To: Edie Berghoff, Associate Planner
From: Michael Bateman, PE, Development Review Engineer
Subject: Crystal View Post Decision Review
Date: December 10, 2018

The Crystal View Post Decision Review/Plat Modification, Planning File P-06-18-18-01 was received and reviewed by the Engineering and Public Works departments. The following memo provides Engineering and Public Works comments and conditions on the proposed modifications.

Geotechnical Report Addendum No: 3:
Stormwater Detention Vault
Proposed Crystal View Residential Plat
Poulsbo, Washington
PN: 24260130512009, 2426013004007
Doc ID: CrystalViewLLC CrystalView.RG.A(3)

Project			CrystalView.Poulsbo		
	Analysis Description			Proposed Seismic		
	Drawn By	CC	Scale	1:400	Company	GeoResources, LLC
	Date	8/22/2018, 9:00:32 AM		File Name	CrystalView.PoulsboVault.slmd

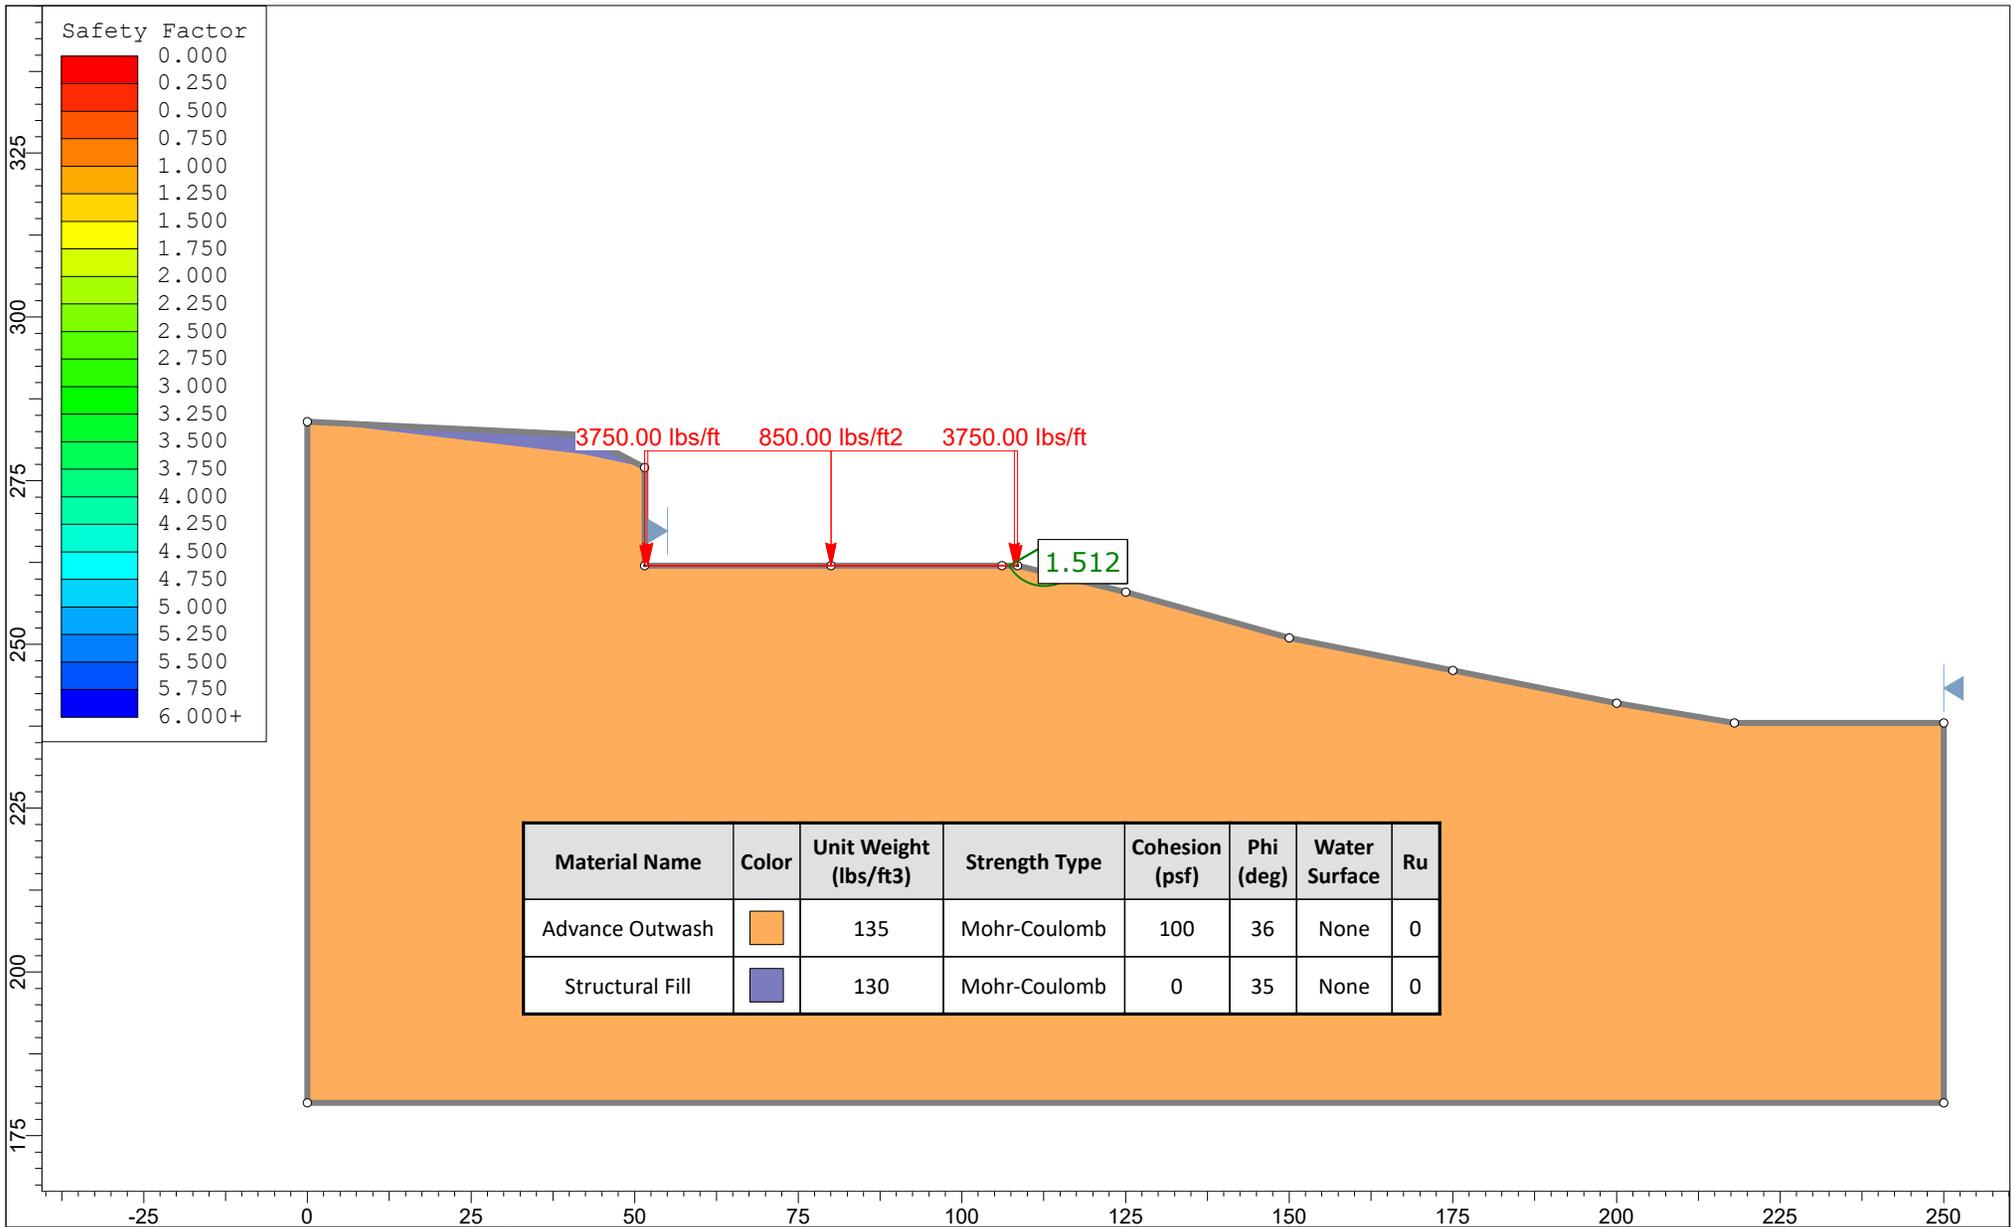
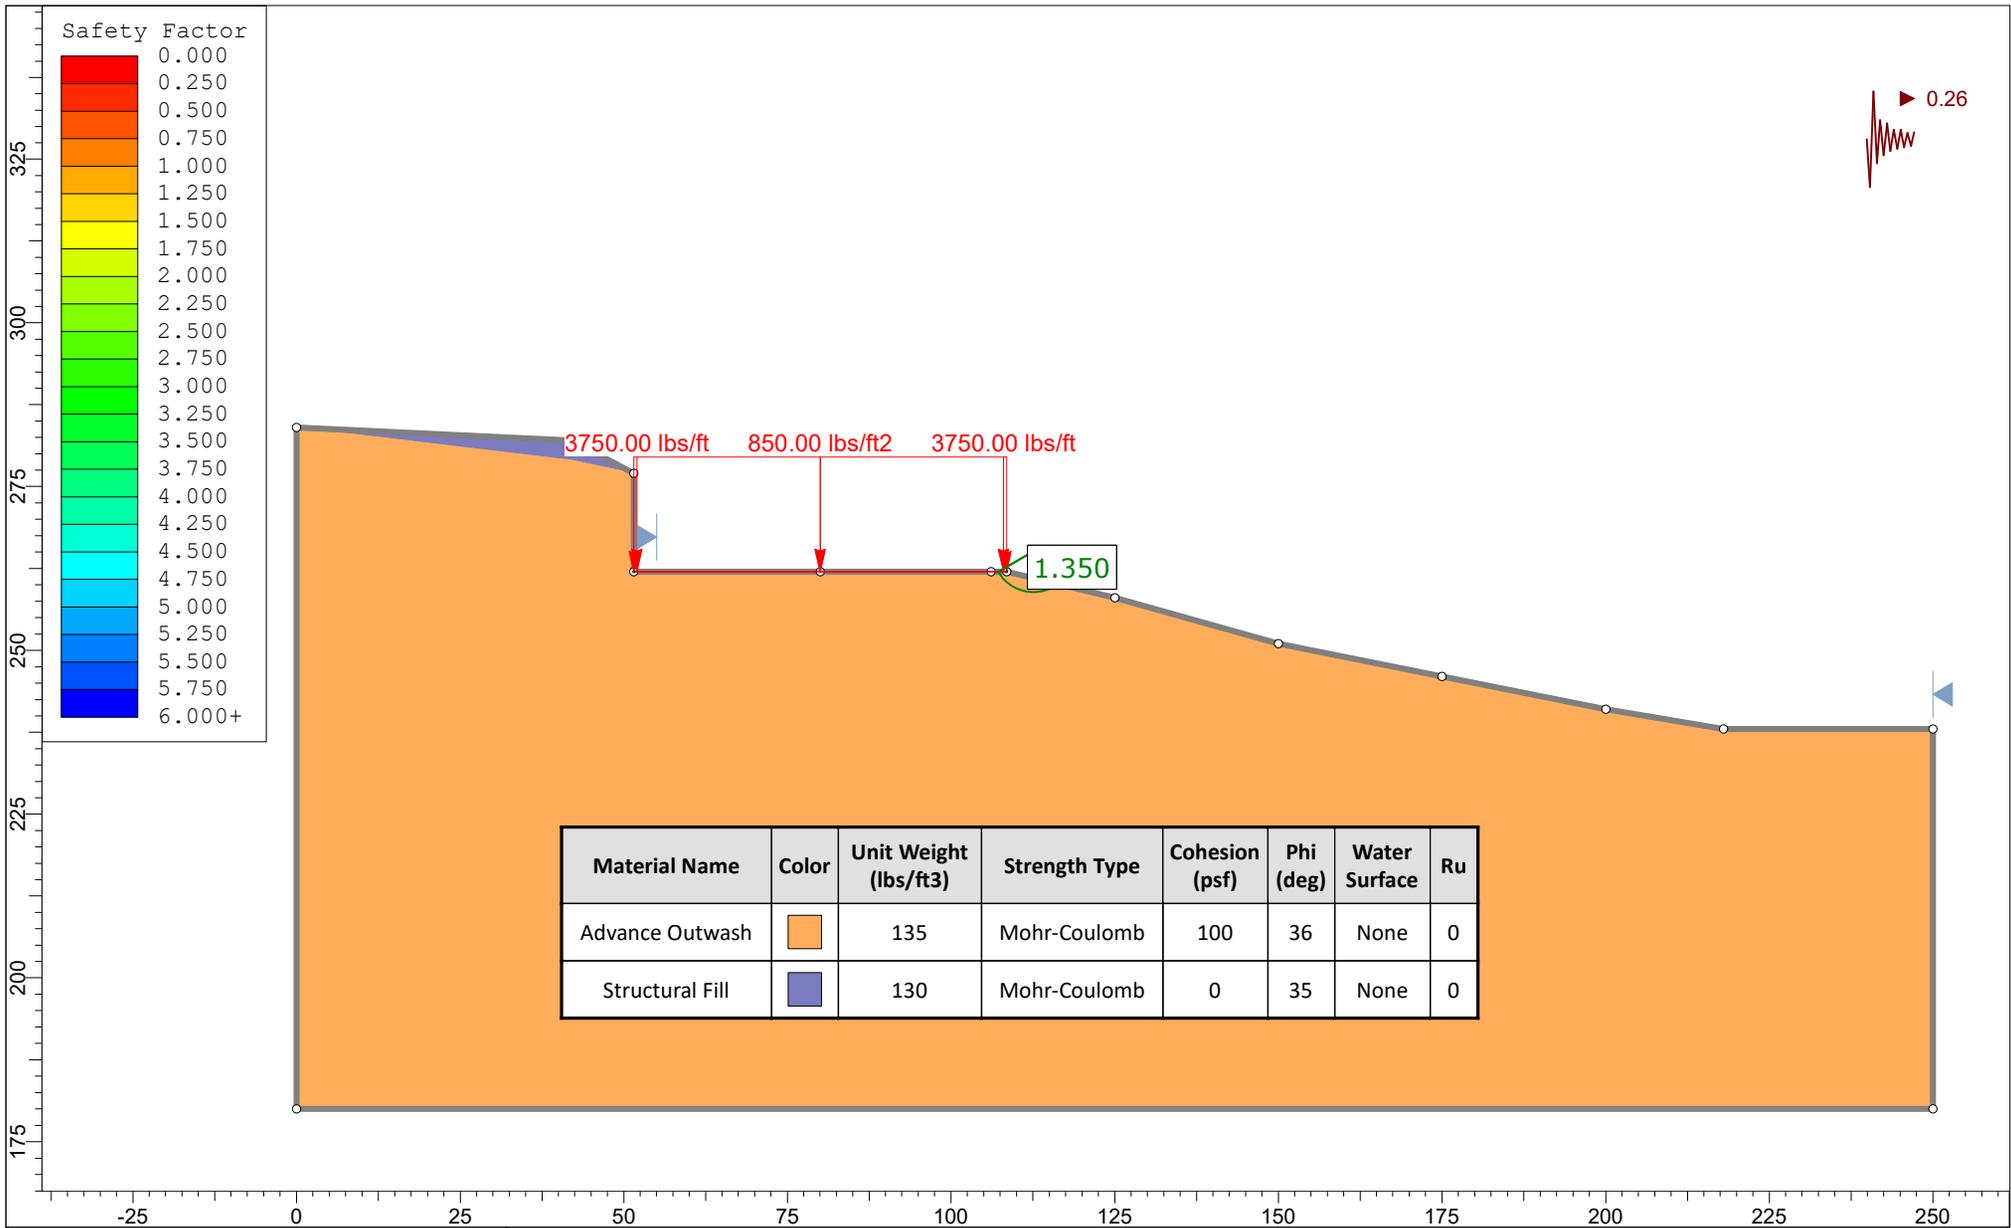
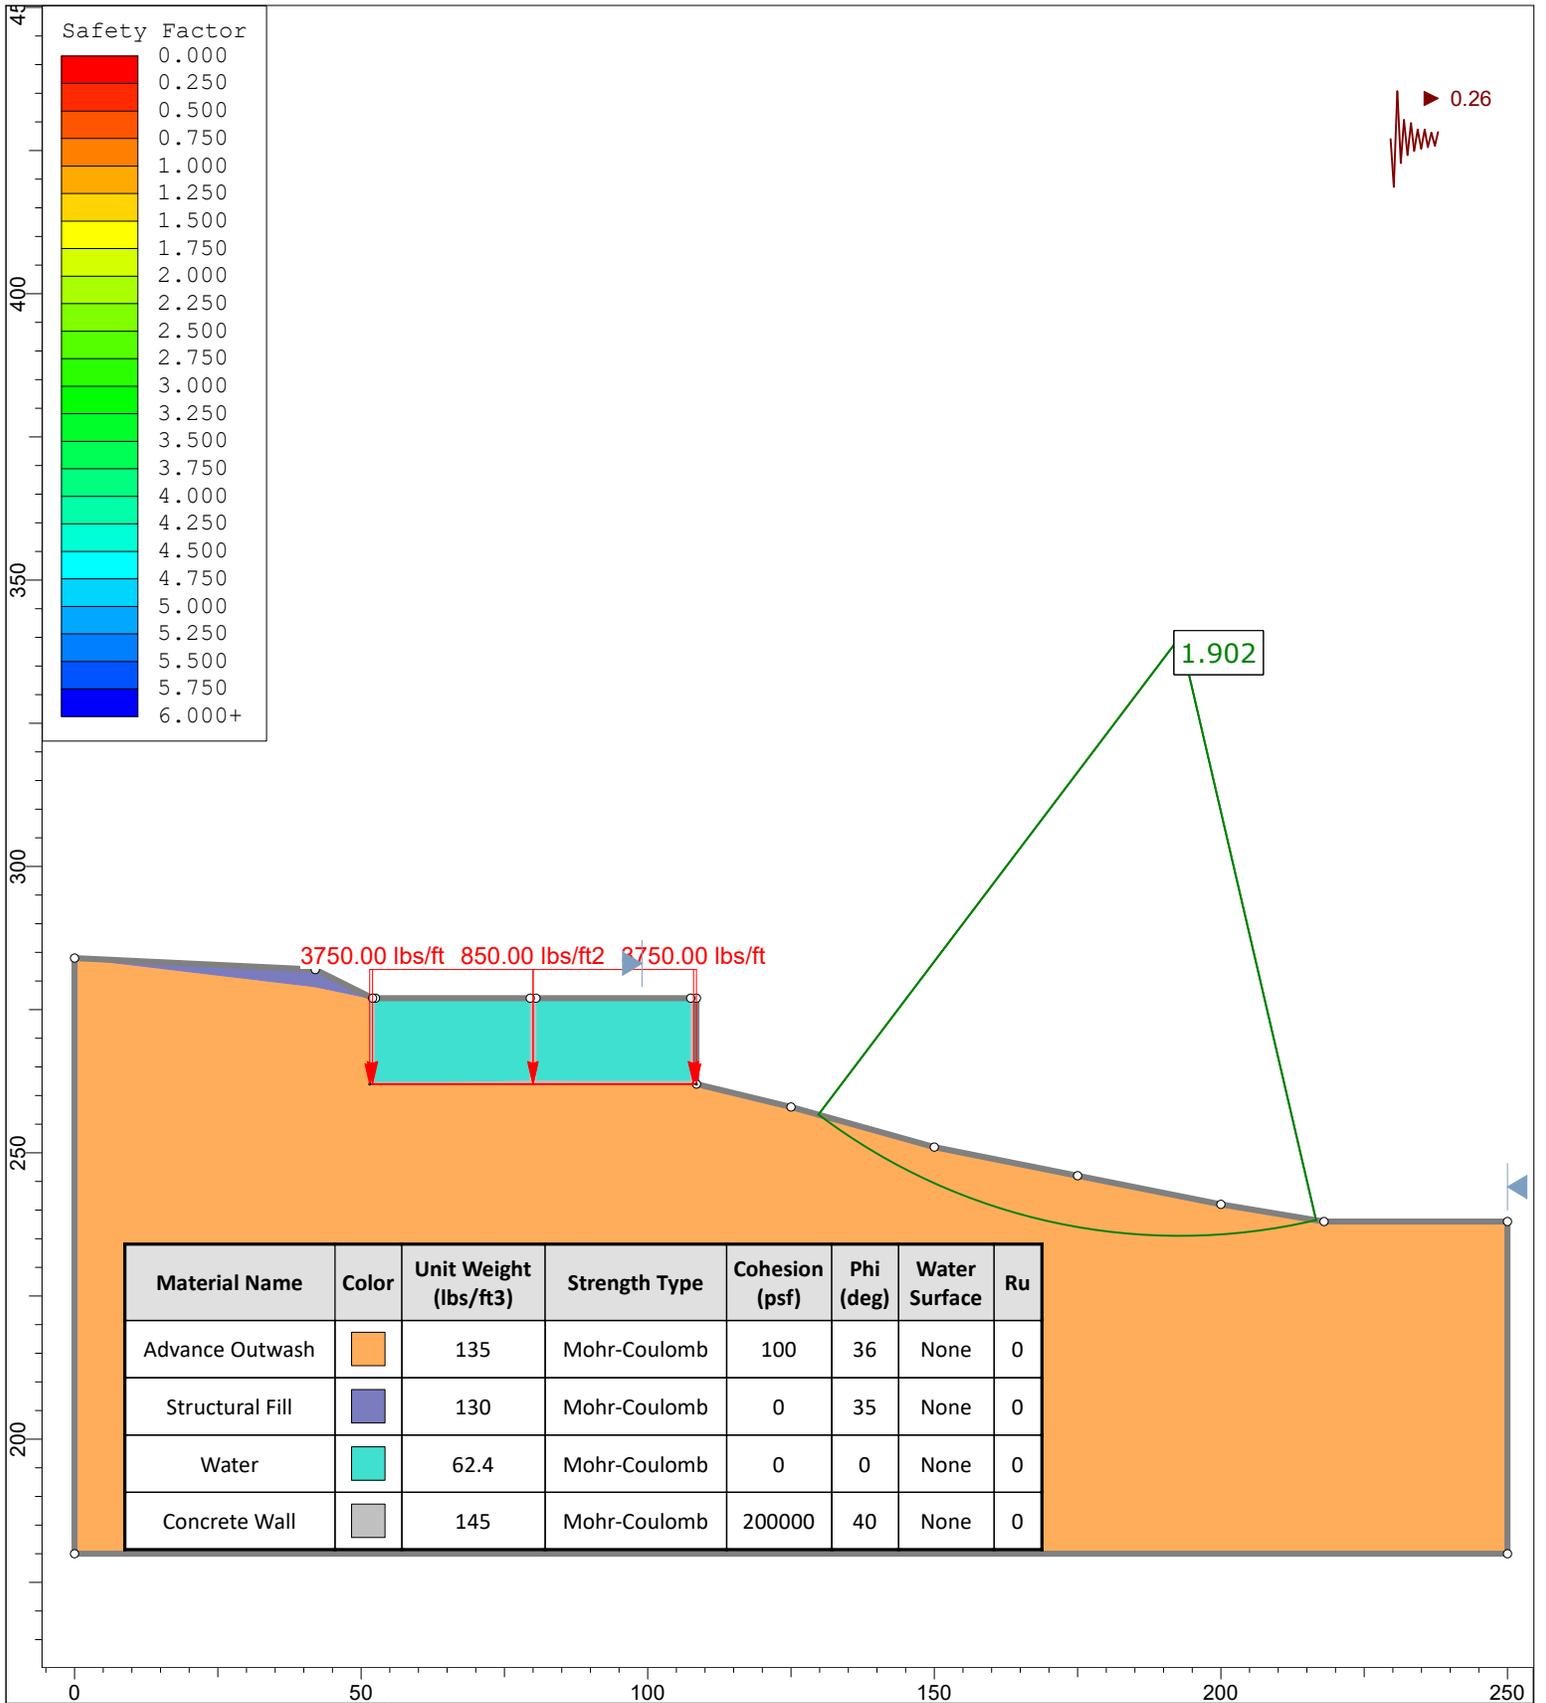
The applicant requests construction of storm vault with Division I, eliminating the temporary storm pond in Division II. As a normal part of construction drawing review, applicant has finalized the storm drainage report and stormwater system design. Storm vault dimensions have been revised to comply with revised final storm drainage report and final storm drainage design. Water quality treatment and offsite conveyance have been revised. Geotechnical report addendum #3 submitted by GeoResources supports the design of the vault, its location, and slope stability.

The revised stormwater vault design and supporting documentation have been reviewed by the Engineering and Public Works departments and found to be consistent with the requirements of the project's vested DOE stormwater manual, City construction standards and Engineering and Public Works Departments conditions of approval.
